MANPRINT ASSESSMENT OF THE
HIGH MOBILITY MULTIPURPOSE WHEELED VEHICLE
HEAVY VARIANT (HMMWV-HV)
(Contract MDA903-83-C-0033)

March 1988

MANPRINT ASSESSMENT:

HIGH MOBILITY MULTIPURPOSE WHEELED VEHICLE HEAVY VARIANT (HMMWV-HV)

Figure 3.3.2. Litter loading and unloading ramp.

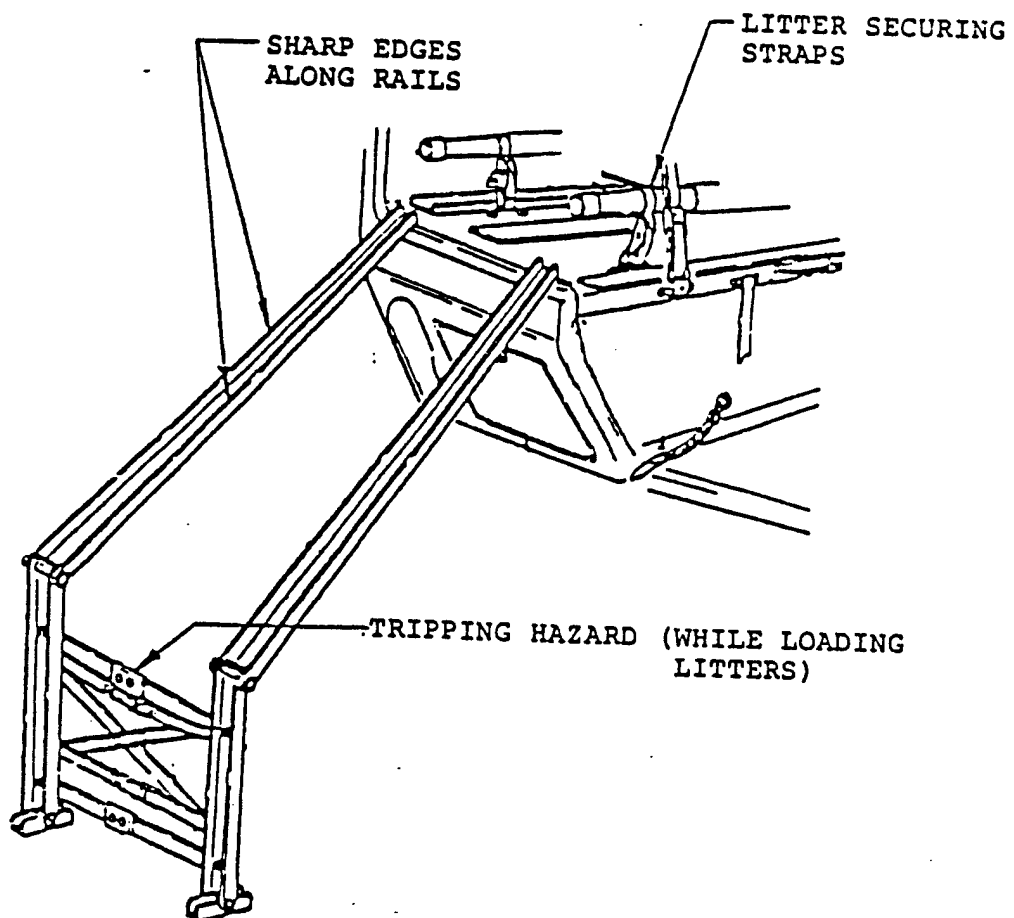
a. The litter bearers' effectiveness to load and unload litters is decreased by (see Figure 3.3.2):

c. Difficulty securing upper litter patients while loading in the maxi-ambulance slows the patient loading process.

a. Litter ramp rail edges should be rolled. The litter ramp attachment to vehicle lugs should be altered to increase their ability to stay secured. Loading procedures should be revised to have litter bearers load litters using a side-carry loading method. This method would avoid the litter ramp structure tripping hazard and would also allow for both litter bearers to apply the lifting and pushing forces required to load the litter.

b. Incorporate a litter-securing device that first clamps to the litter. Second, litter securing tension is applied.

Figure 3.3.3. Rear view side mirror.

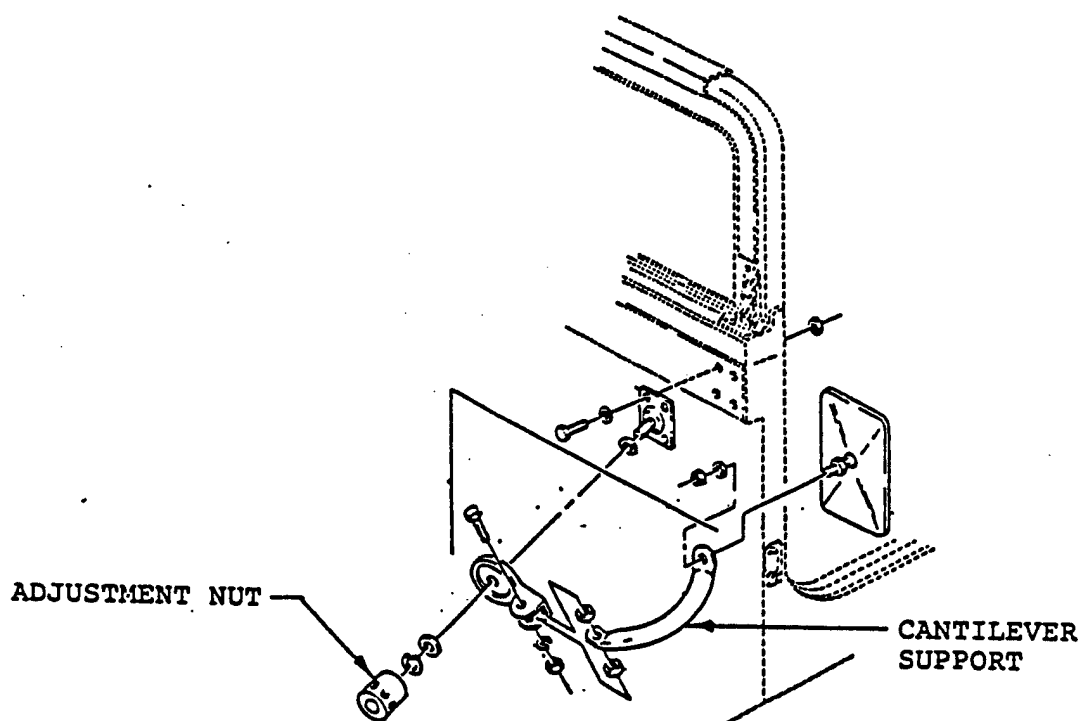
The side mirrors on the HMMWV ambulances and shelter carrier are too small and vibrate excessively. The hardware for mirror adjustment to the window frame mount vibrates loose, and the mirror falls to the side of the vehicle due to the length of the support. Operators claim the passenger side mirror is poorly positioned and does not provide a view. Shelter carrier drivers complain they do not have adequate rearward view to monitor their trailer status.

The mirror is supported by a single support that is approximately 20 inches (50 cm) long and is cantilevered from the mounting and adjusting hardware (see Figure 3.3.3). Vibration acting on the same plane as the adjustment nut tends to loosen the nut.

Excessive vibration blurs operator's rearward view. Loose hardware disables the use of the mirror. The small size of mirrors, approximately 5 by 7 inches (12.5 by 17.5 cm), limits effectiveness.

a. Increase support of the mirror by adding an extra support member in a triangular configuration.

DESCRIPTION
Figure 3.3.6. Pioneer tool rack attachment.

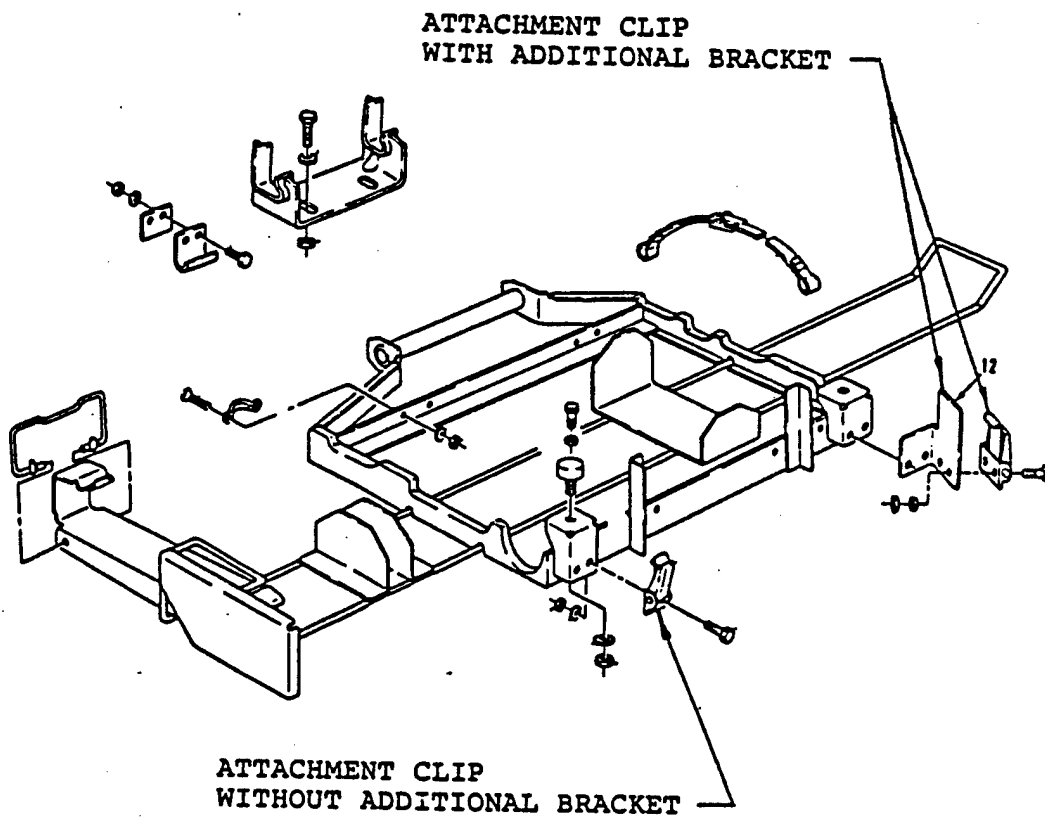
The standard pioneer tool racks that fit the HMMWV cargo or tow will not fit the HMMWV-HV ambulances or shelter carrier. Racks furnished for the ambulances or shelter carrier come with a special angle bracket to adapt the pioneer tool rack to these vehicles (see Figure 3.3.6). One ambulance (B02) was issued a standard pioneer tool rack (including tools) which would not fit beneath the ambulance. These tools were stowed inside the ambulance compartment, interfering with personnel movement inside the compartment.

Pioneer tool sets will not attach universally to all HMMWV vehicles. Situations as described above will occur.

DESCRIPTION
Figure 3.4.1. Shelter mounting kit.

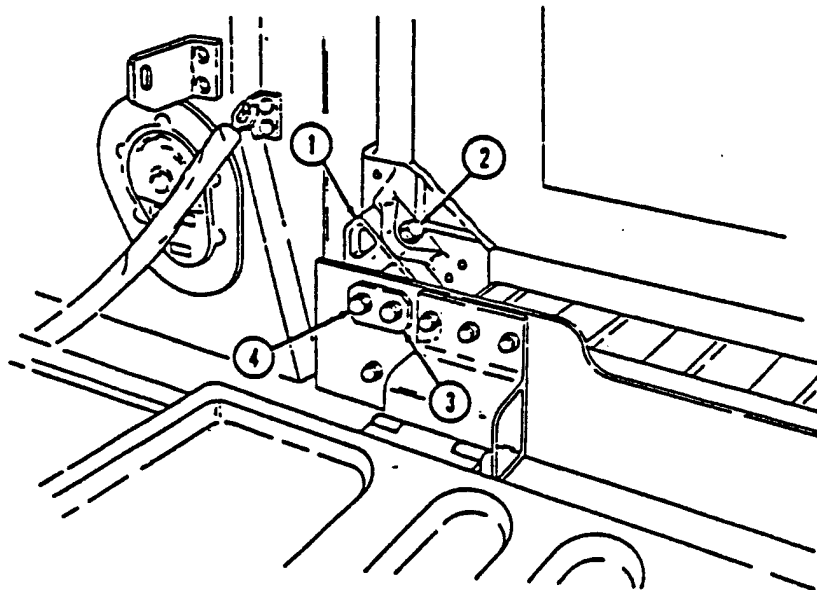
b. The mounting kit bolts (Figure 3.4.1, Items 2 and 4) behind the cab and passenger seat are difficult to align and start.

a. Some of the S-250 shelters will not fit to HMMWV-HVs with the mounts provided by the manufacturer.

b. Crewmen claim it takes up to three times the amount of time to align and start these bolts.

a. Design the shelter mount to accommodate both versions of the S-250 shelter.

b. Instruct personnel to remove passenger seat when installing the shelter on the HMMWV-HV.

Figure 3.4.2. Oxygen bottle racks.

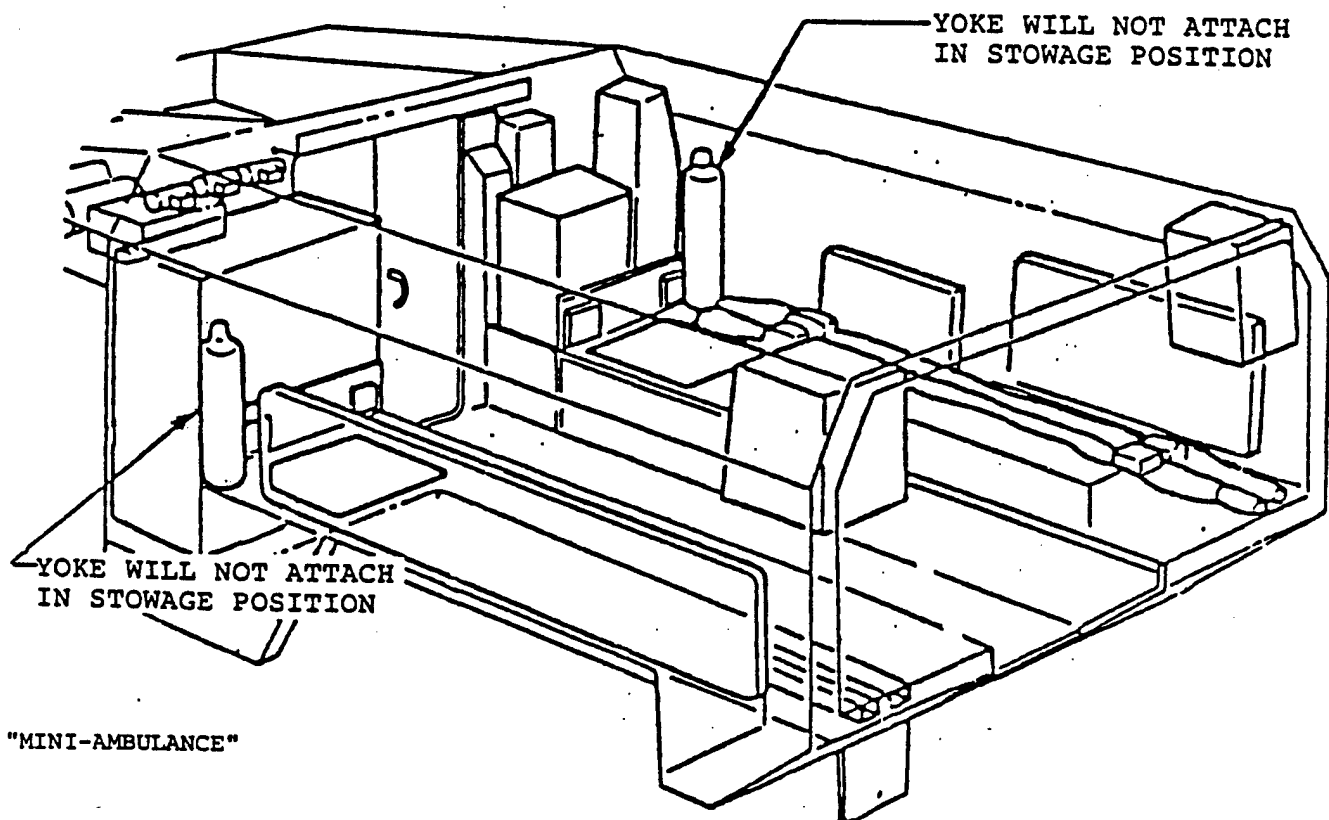
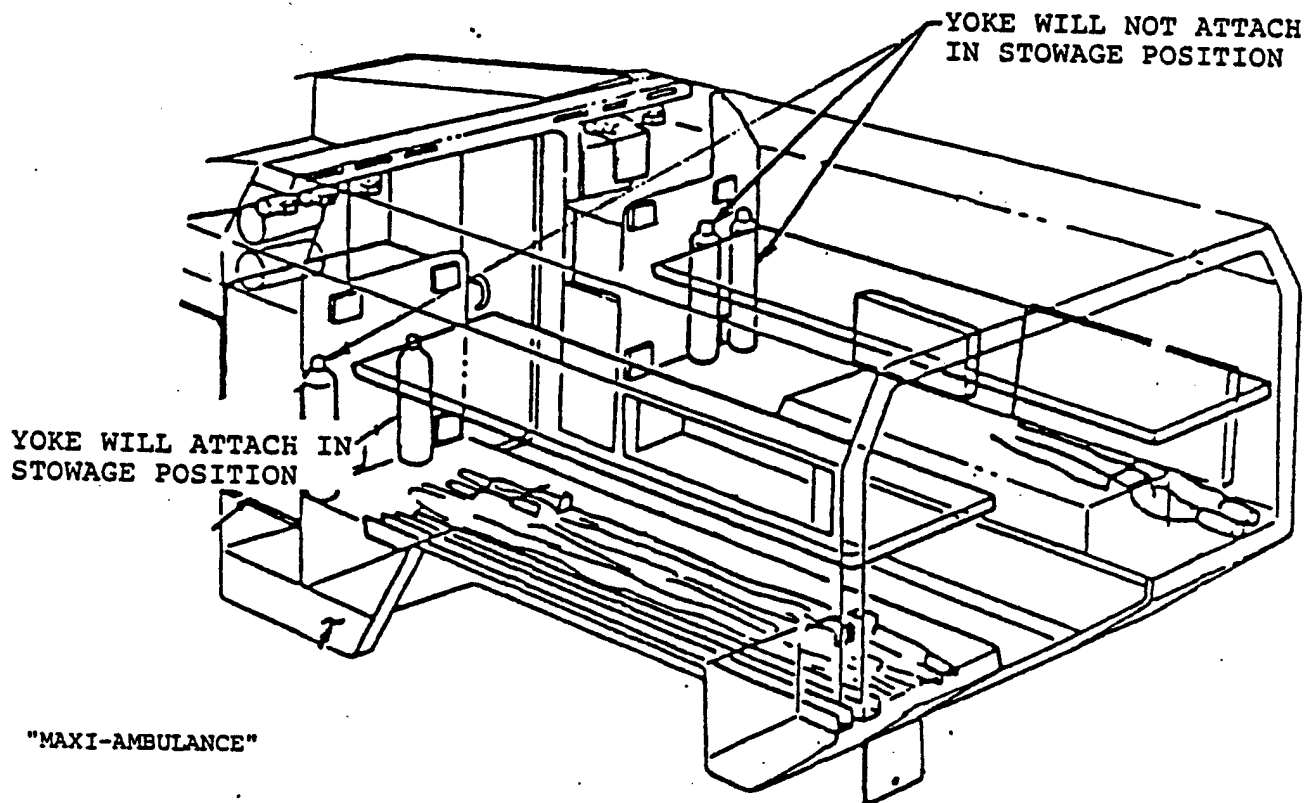
The oxygen bottle rack mounts position the bottles without enough room to allow for the attachment of the yoke adapters. Bottles cannot be put into service in stowed position at present. Only one rack position in the maxi-ambulance (see Figure 3.4.2) will allow the O₂ bottle to be made ready (with the yoke attached) for operation while in the stowage rack. There are no provisions to secure oxygen bottles to litters if the oxygen bottles are placed next to patients on litters.

Oxygen bottles are not usable unless they are removed from rack and cannot be stowed until after yokes are removed. Bottles that are not secured during use or layed on the patient's litter may be thrown about a moving vehicle and cause injury to aidmen or patients.
